Approved Section 75W Modification Application

in respect to MP 09_0153

UTS
DR CHAU CHAK WING BUILDING

MP_09_0153-01-75w submission
Floor plan mark-ups

**GROUND LEVEL
LANDSCAPE PLAN
HARD SURFACES**

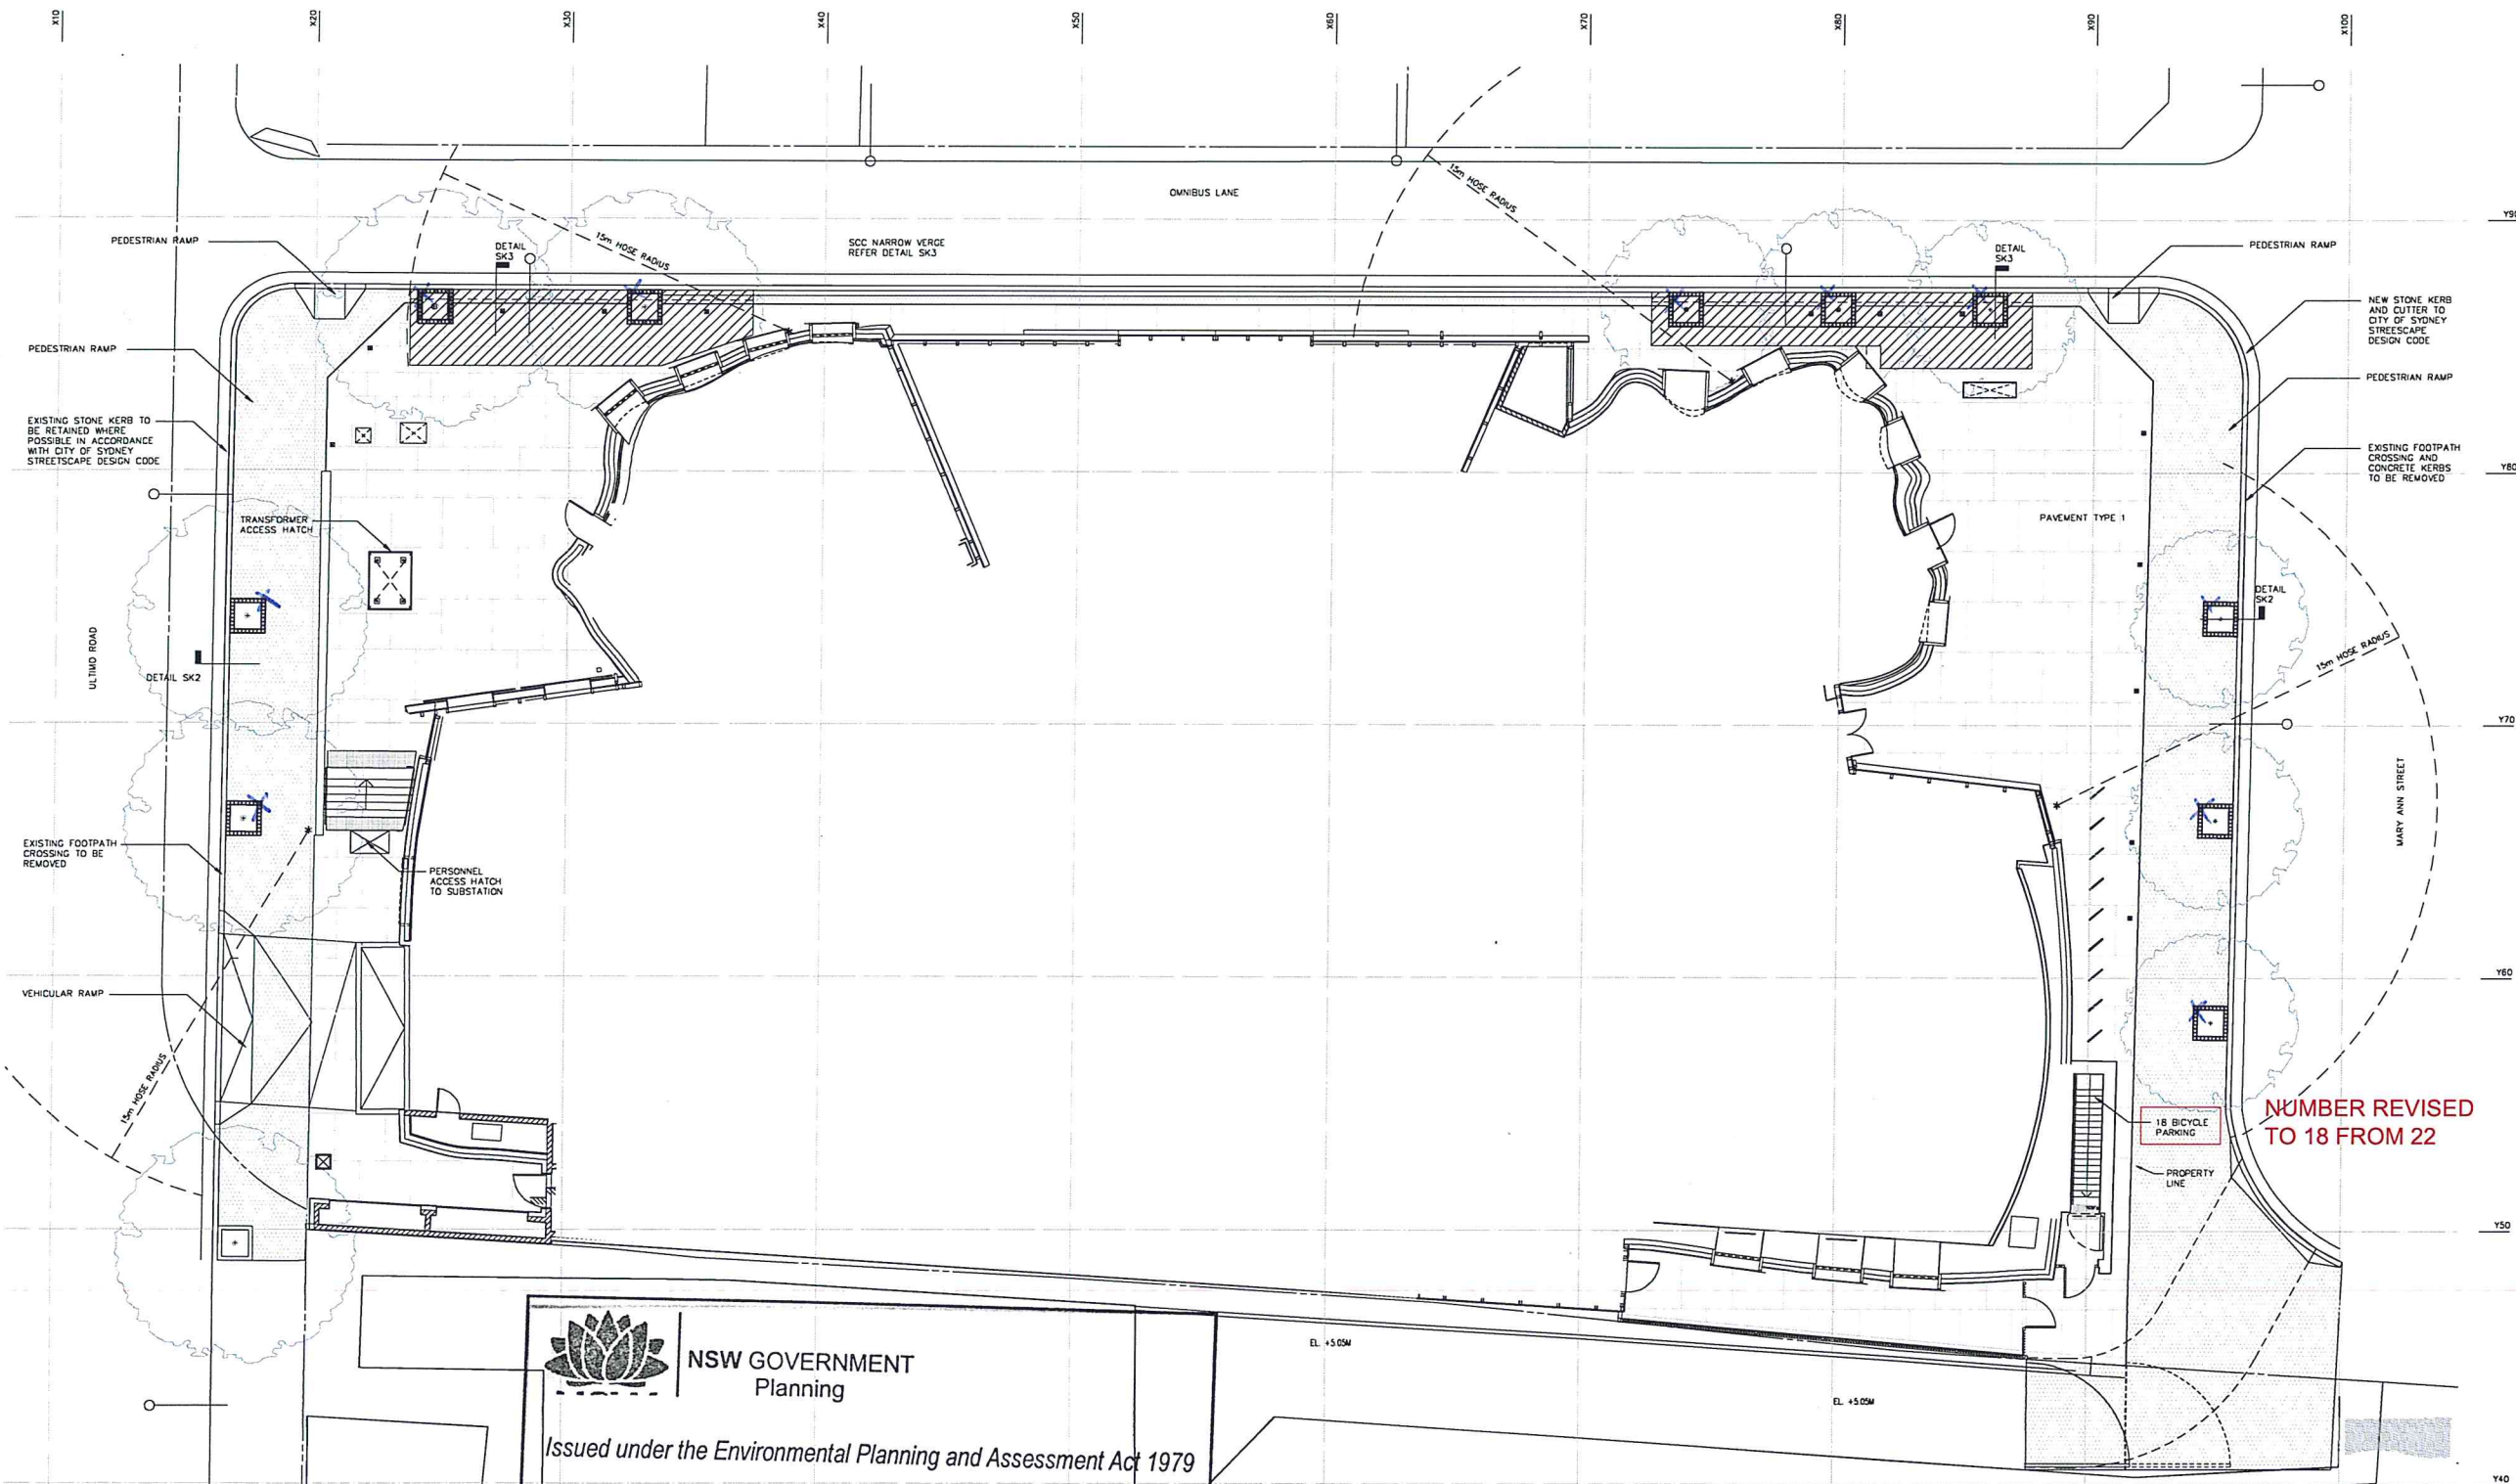
**DESCRIPTION
UPDATED**

**NUMBER REVISED
TO 18 FROM 22**
